**RE: South Green Avenue Site
Detroit, Michigan**

The *Excavation/Off-Site Disposal Removal Action Work Plan* (May 24, 2001) pertaining to the above-referenced Site was previously submitted to the U S EPA. This work plan is subsequently referred to as the "Excavation Work Plan". In a June 8, 2001 letter, Altech Environmental Services, Inc (Altech) submitted a correspondence to the U.S. EPA that provided comments on the Excavation Work Plan. Altech is a subcontractor to the U S EPA's Superfund Technical Assessment and Response Team (START) contractor, Tetra Tech EM, Inc. On June 12, 2001, a meeting was held among MichCon, IT, the U S EPA, the City of Detroit, Tetra Tech and Altech to discuss the Excavation Work Plan and Altech's comments. The objective of this correspondence is to provide responses to Altech's comments. Altech's comments are presented below in *italics* and responses are presented after each comment. References to sections refer to the Excavation Work Plan.

MAP OF FORMER MGP STRUCTURES

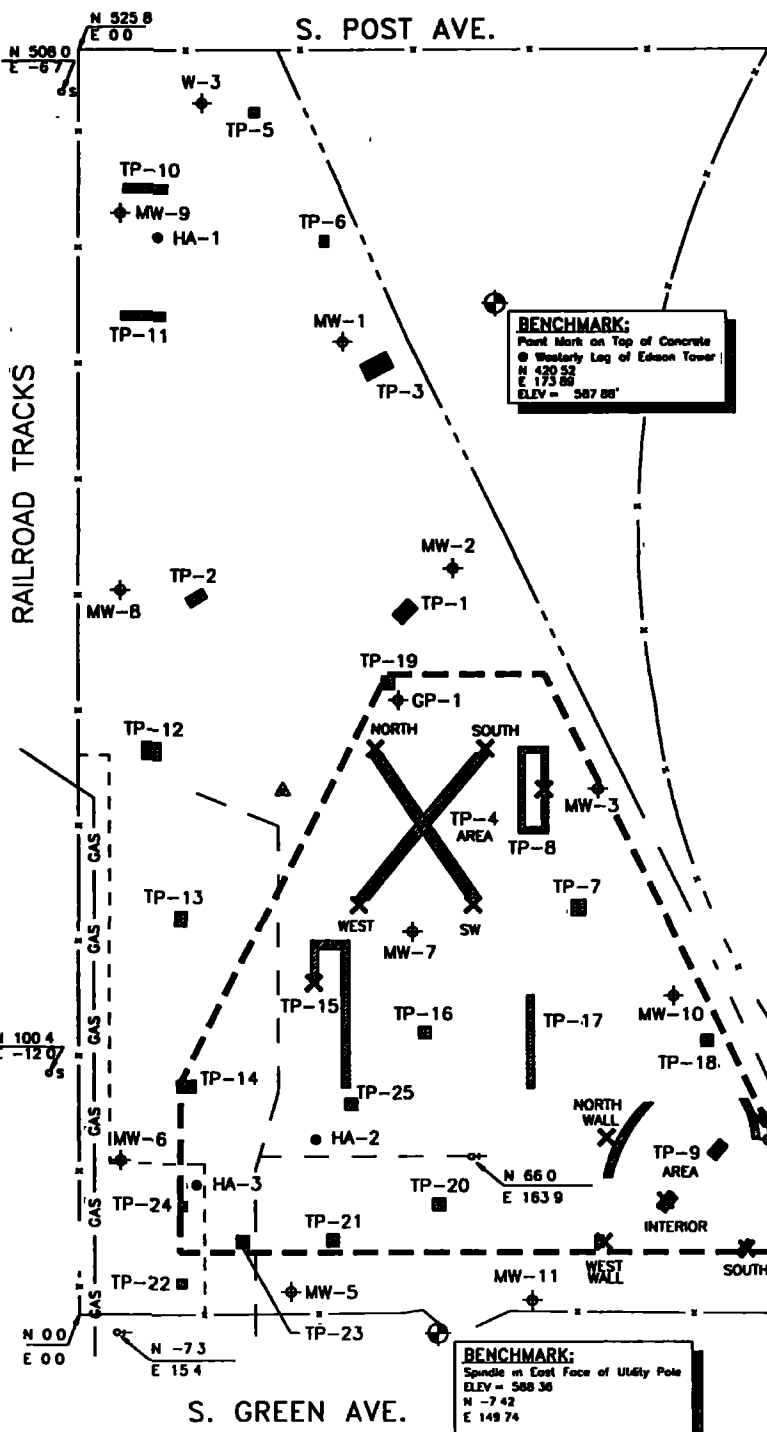
The work plan should describe the agreement reached with the owner of the Site, the City of Detroit, with regard to removal of paved areas, foundations of buildings and equipment, and underground piping and utilities. In addition, the work plan should explain how MichCon will determine which foundations will require removal "to gain access to the targeted materials". Especially with regard to the concrete foundations of the two gas holders, the work plan should discuss how MichCon will verify that the foundations have not leaked, and that targeted materials have not seeped under the foundations.

Figure 3 of the Excavation Work Plan (enclosed) presents a map showing the former MGP structures. The current locations of some concrete surface foundations are indicated on this map as building outlines. Figure 6 shows the maximum anticipated excavation area. Based on the EE/CA, the concrete surface foundations that may potentially be removed are (see Figure 3):

- Old pipe shop
- Old purifying house
- Spray pond building
- Oil house
- Wash house
- Water gas plant

Subsurface concrete associated with underground tar tanks and tar wells and underground piping will also be removed, if impacted. The two concrete gas holder foundations are situated approximately two to three feet below the surface. During previous investigations, these concrete gas holder foundations were observed to be good condition and, as stated in the EE/CA, are not required to be removed. During excavation activities, the gas holder foundations will be uncovered. The top of the foundations will be inspected for cracks, seams and other faults. If visually impacted materials are observed around the sides of the foundations or to have migrated completely through cracks, the concrete foundations will either be removed or a boring(s) will be advanced through the concrete in order to inspect samples of the materials below the concrete foundations. If waste materials are observed beneath the foundations, the waste materials will be excavated for off-site disposal.

FIGURE 6
MICHIGAN CONSOLIDATED GAS COMPANY
SOUTH GREEN AVENUE
DETROIT, MICHIGAN
MAP SHOWING APPROXIMATE MAXIMUM
EXTENT OF POTENTIAL REMOVAL ACTION

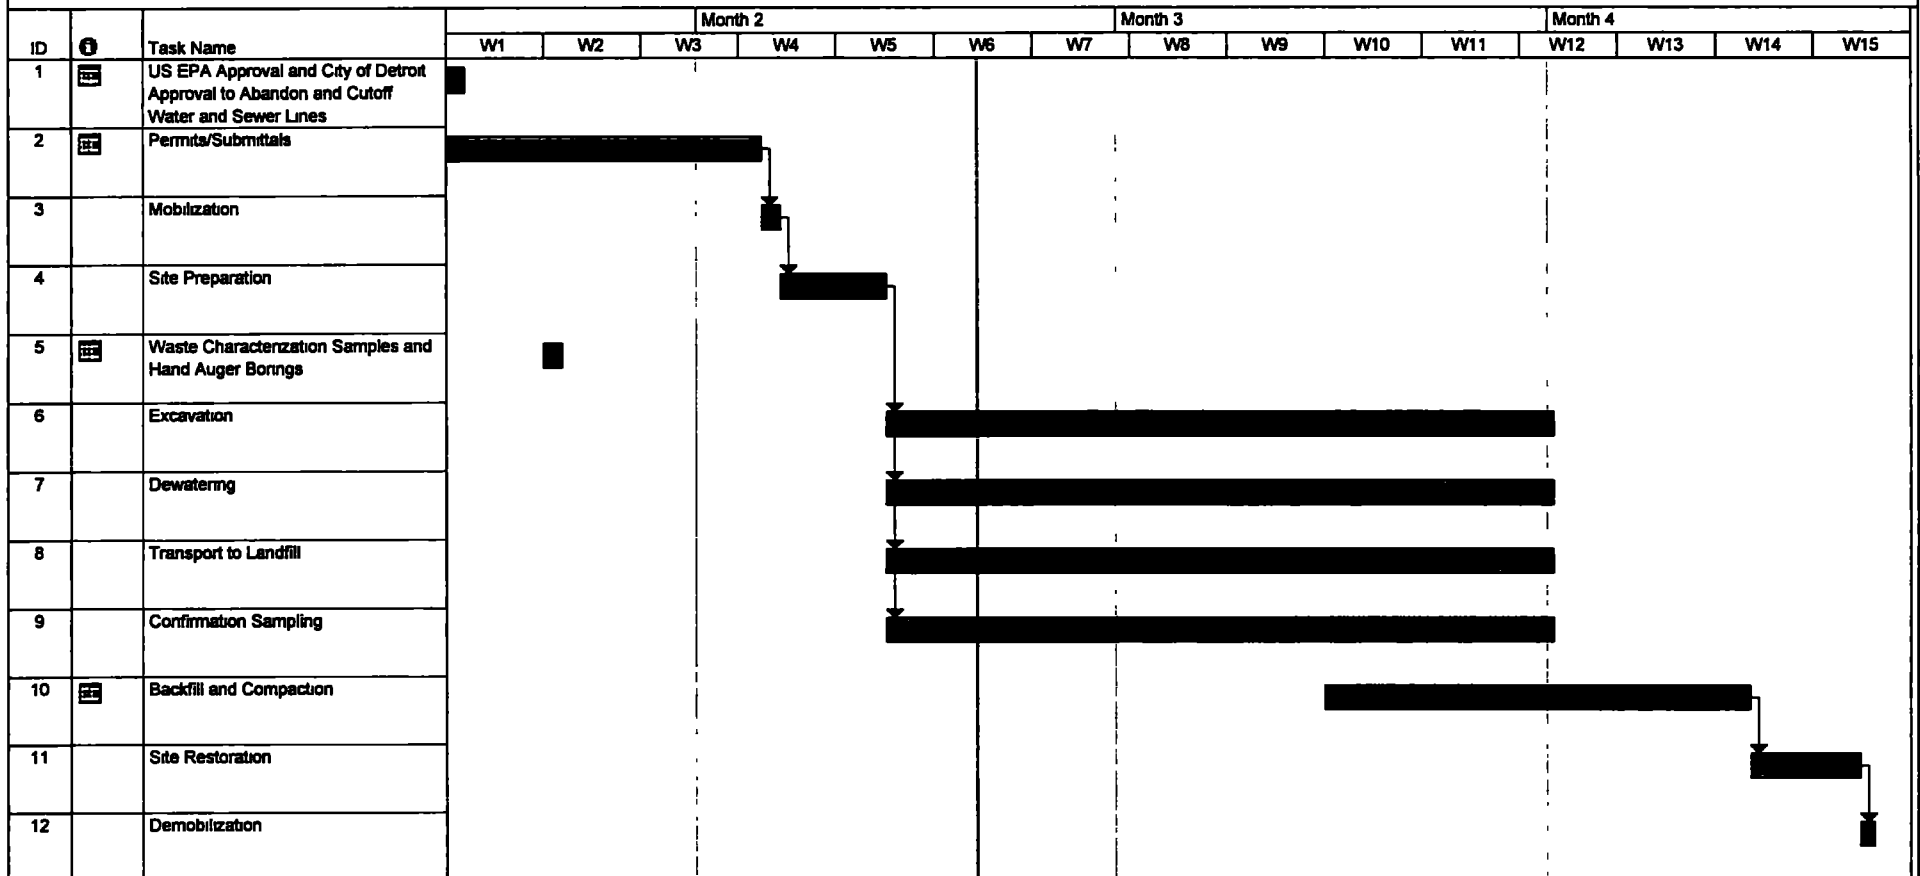
The range of concentrations of the constituents of concern is identified. However, the extent of the contamination requiring remediation is not. The work plan should state whether any of the analytical results for soil samples collected outside the "Approximate

Maximum Extent of Potential Removal Action" area exceed the applicable cleanup criteria. All areas where constituents of concern were found at concentrations above the cleanup criteria should be identified.

Figure 9 (enclosed) shows the sample locations outside the "Approximate Maximum Extent of Potential Removal Action" that exceed the industrial generic cleanup criteria listed on Table 3 of the Excavation Work Plan. As indicated on this map, only three sample locations exceed these cleanup criteria: MW-8 surface sample (only benzo(a)pyrene exceeded criteria), TP-2 (three feet below the surface: only benzo(a)pyrene exceeded criteria) and SS-2 surface sample (only lead exceeded cleanup criteria).

Figure 8 (Revised)
Anticipated Project Timeline
Excavation/Off Site Disposal Removal Action
South Green Avenue Site
Detroit, Michigan

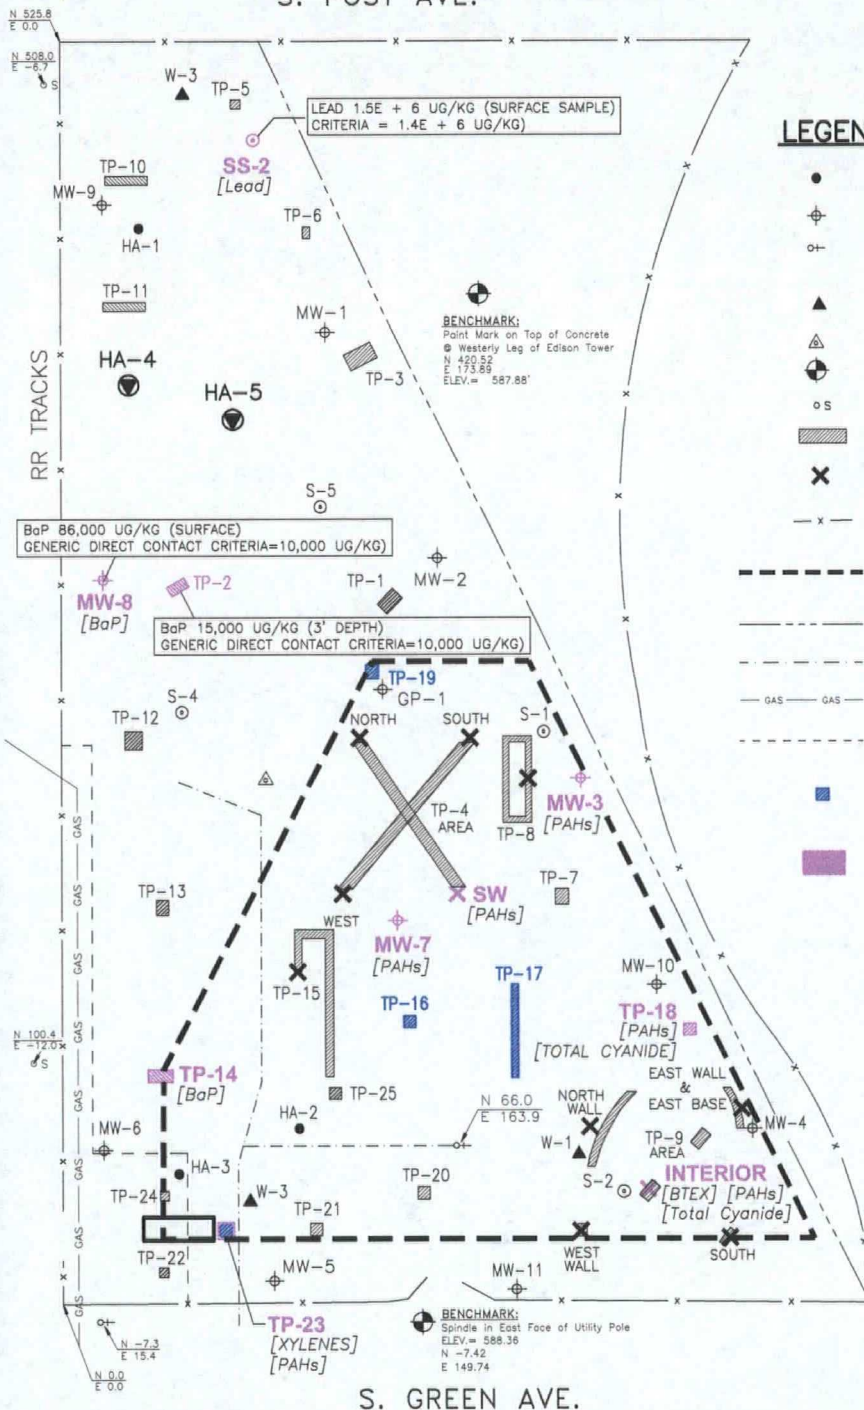
MichCon needs to document the remediation of the Site in a final report. The work plan should state who will prepare the report and when it will be submitted

The anticipated removal action implementation schedule referred to in Section 7.0 has been revised to include the hand auger borings and a determination by the City of Detroit regarding the request to abandon/cut off the water and sewer lines.

REVISED HOSPITAL LOCATION MAP

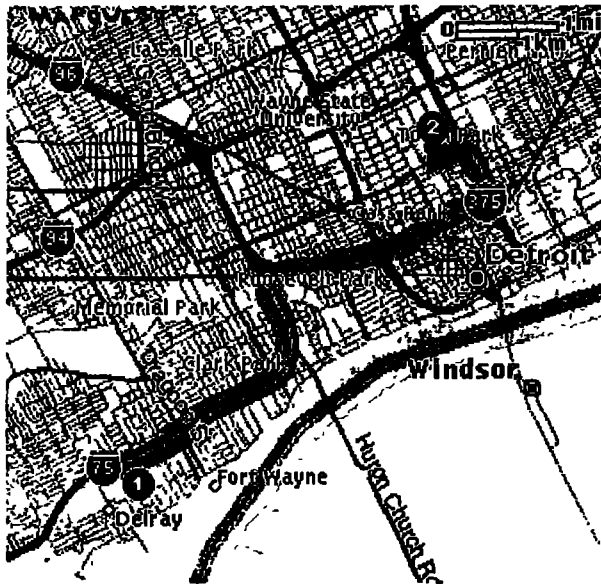
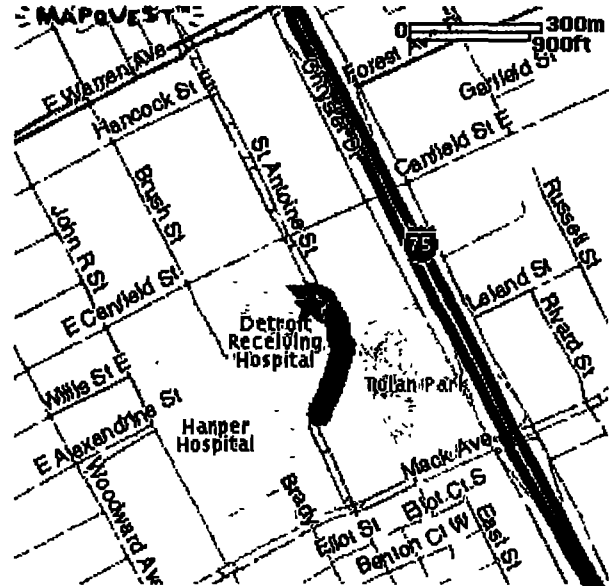
The work plan should specify whether (1) the health and safety plan (HASP) covers MichCon as well as all of its subcontractors and (2) the HASP addresses site security and vandalism

The HASP covers MichCon's subcontractors. The HASP provides emergency information such as phone numbers for ambulance, fire, police and hospital. The Excavation Work Plan included an amendment to the HASP. This amendment has been modified since the hospital referred to in the HASP appears to no longer be in operation. The revised cover amendment (enclosed with revised hospital location map) provides address, phone number and location of a qualified emergency hospital.
